Product Change Notification: P-21-021385

HVP 800 HEADER

Paper package changed to plastic board packaging

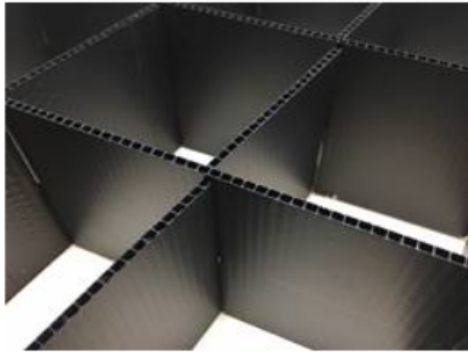
before change	after change
<p>Before Change</p> <p>Partitions and pads material was corrugated board 隔挡和衬板材料是瓦楞纸板</p> 	<p>After Change</p> <p>Partitions and pads material will be plastic hollow plate 隔挡和衬板材料是塑料中空板</p>
